**Addendum No. 1**  
**January 12, 2024**

Project: **Lennox High School Addition**  
Lennox, South Dakota  
Architecture Incorporated Project No.: 2982

6.10-G

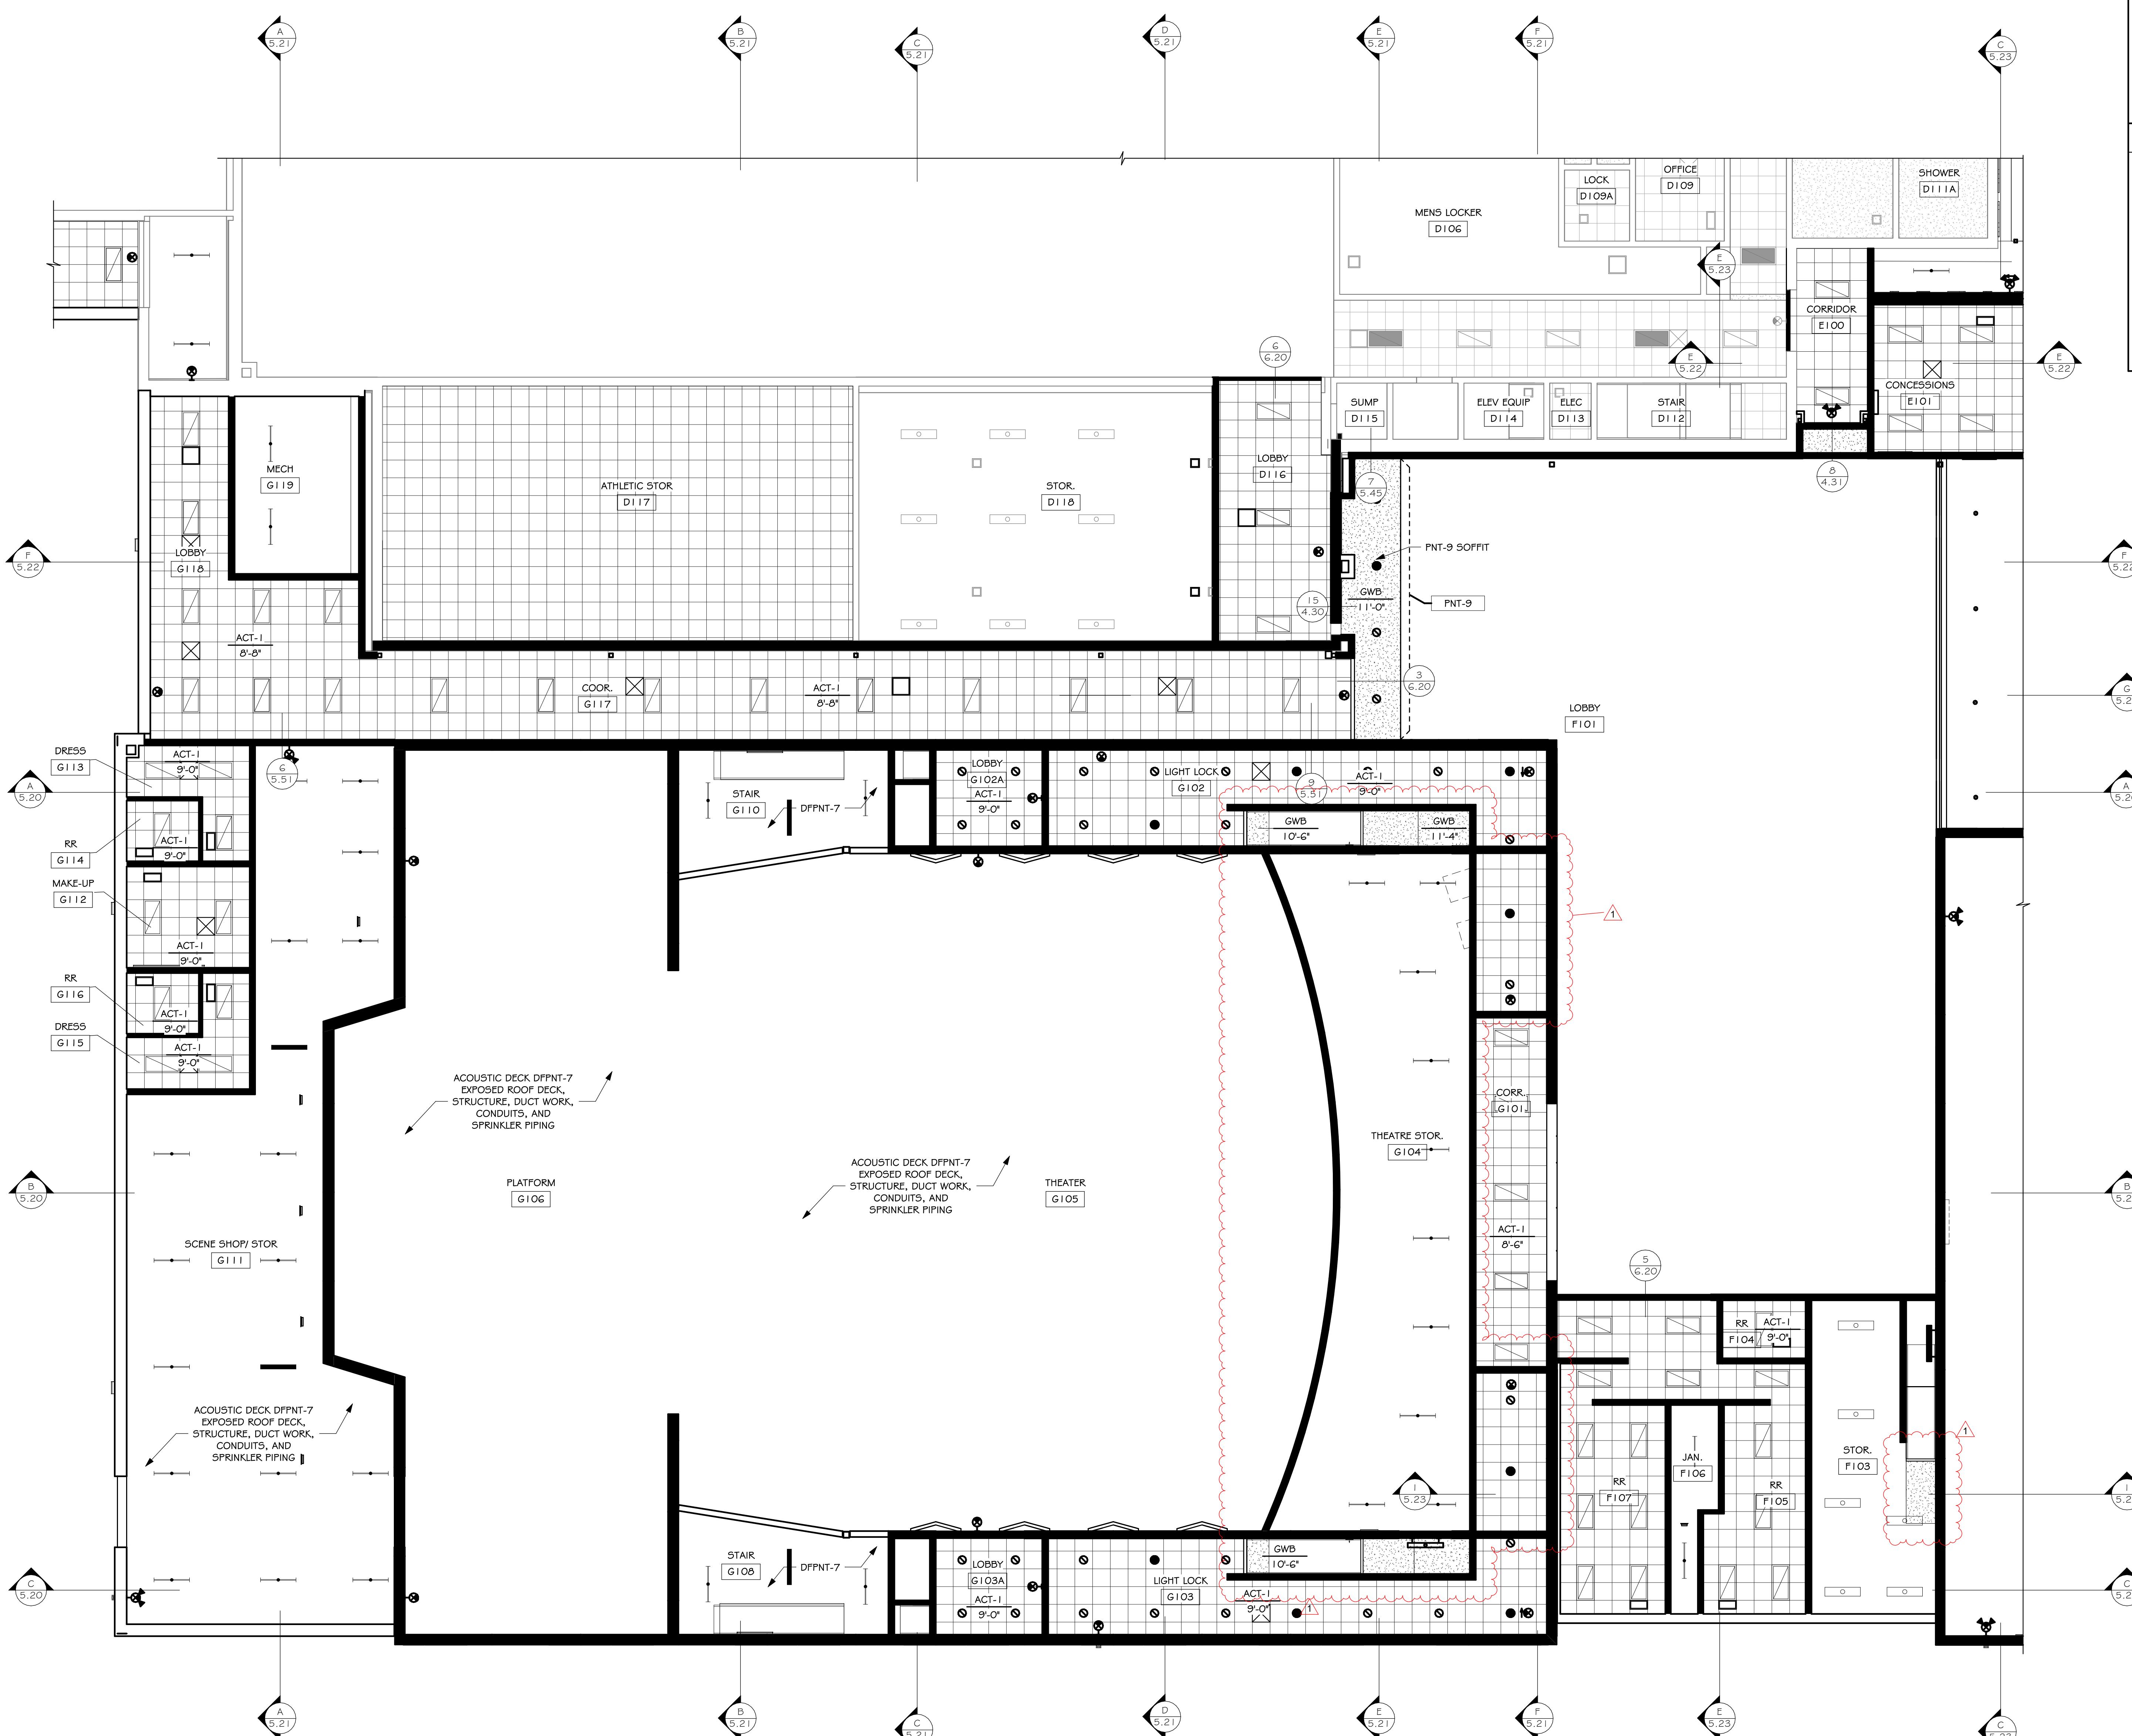
- a) Reference *revised* drawing Sheet 6.10-G, dated 1-11-24, attached to the end of this addendum for the following:
- i) Add gypsum board to the underside of stair assemblies Stair G102B & Stair G103B and to the underside of the stair assembly up to Mechanical Penthouse G207.
  - ii) Clarifications regarding extent of walls required to extend vertically to structure above.

8.40-E

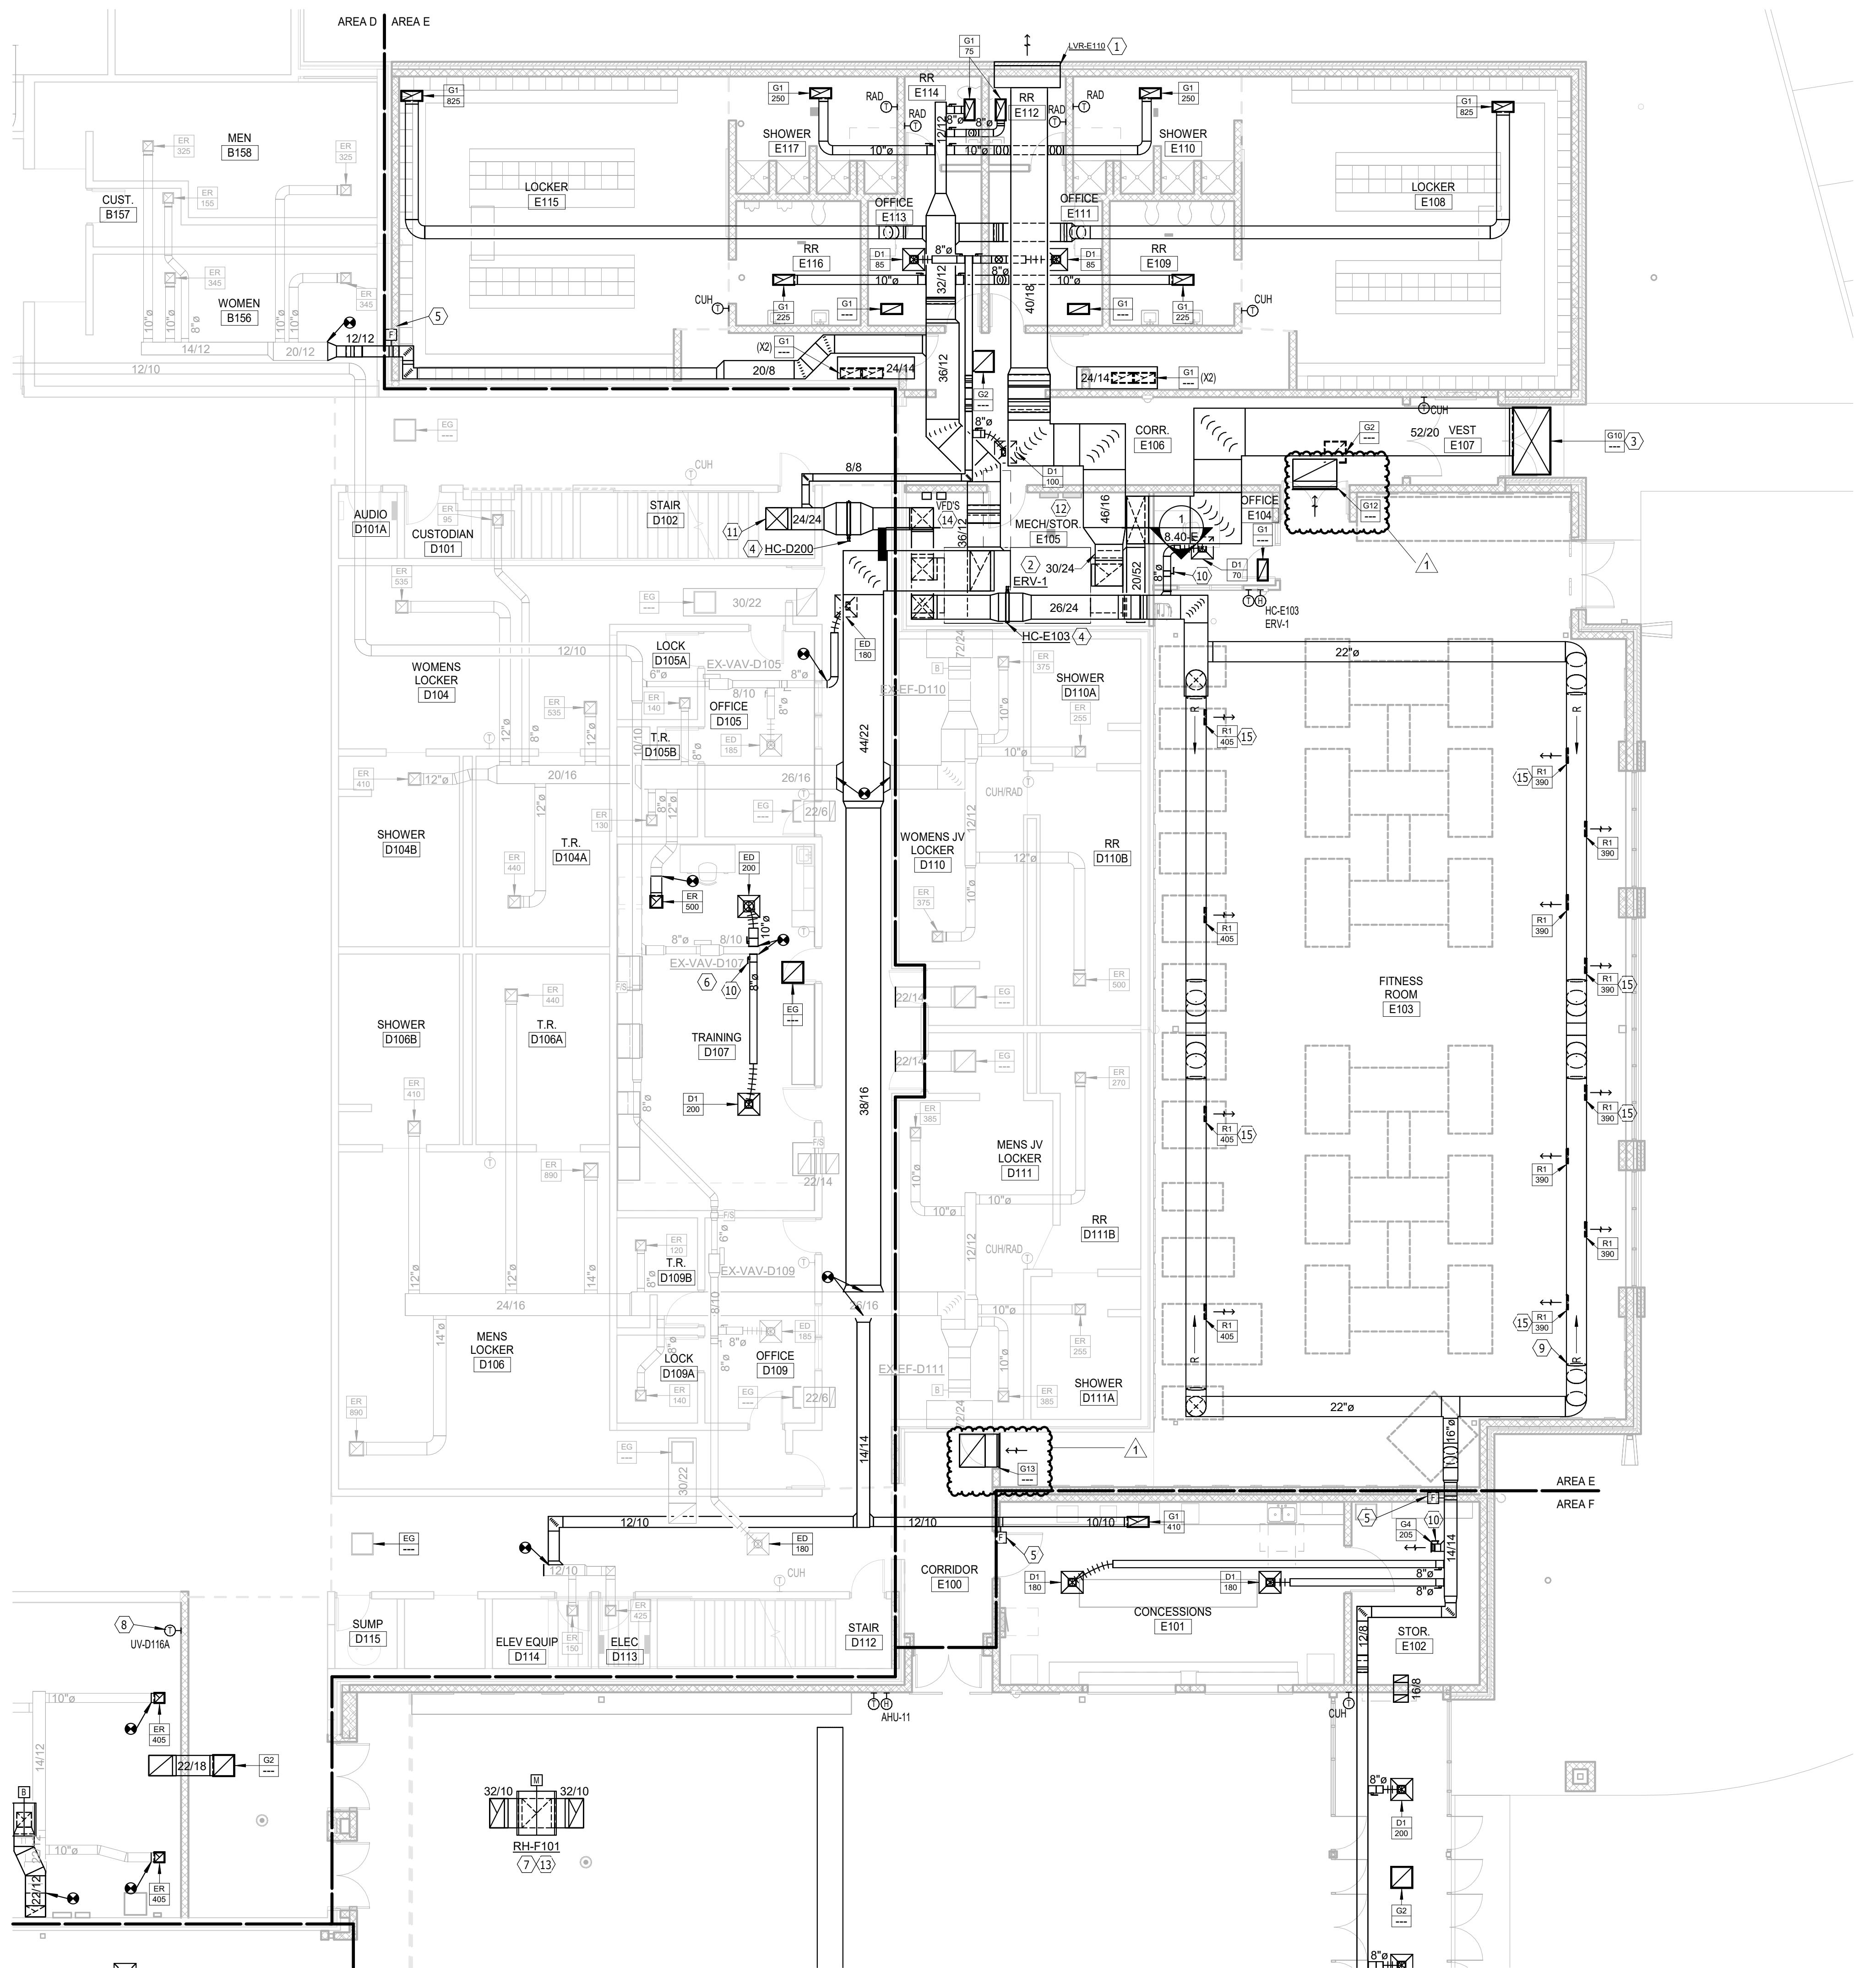
- a) Add G12 and G13 grilles and ducts as shown for Fitness Room E103 for transfer out.
